Compliance Recall 23C24 – SUPPLEMENT #1

Certain 2023 Model Year F53/F59 Stripped Chassis

SDLC Module Waterlogged during Engine Rework

NEW! REASON FOR THIS SUPPLEMENT

FIGURE 4

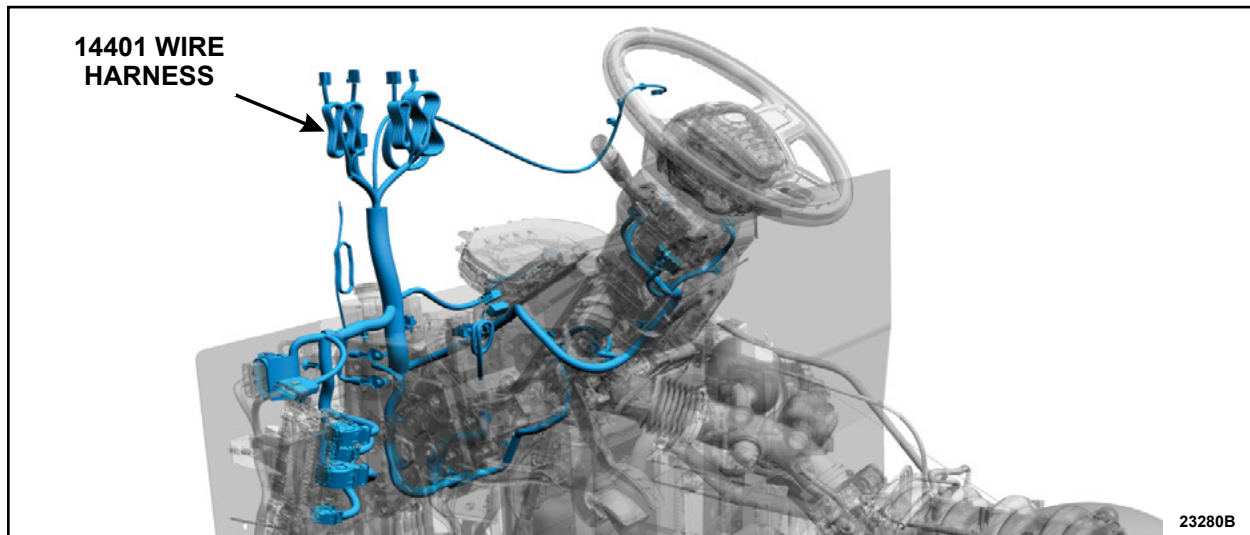
7. Is the vehicle equipped with a Telematics Control Unit (TCU).

8. Remove the driver side A-Pillar trim from the vehicle.

9. Remove the 14401 harness from the vehicle up to the A-Pillar. See Figure 4.

10. At the half-way point on the A-pillar, cut and discard the 14401 harness.

11. Inspect the wires in the remaining section of the 14401 harness at the A-pillar for any signs of corrosion or greening. Was any signs of corrosion or greening present?

YES - Remove the remaining section of 14401 harness. Proceed to Step 16.

NO - Proceed to Step 12.

12. Install the new 14401 harness. Once at the A-pillar, splice in the new 14401 harness to the original harness using wire crimps and heatshrink.
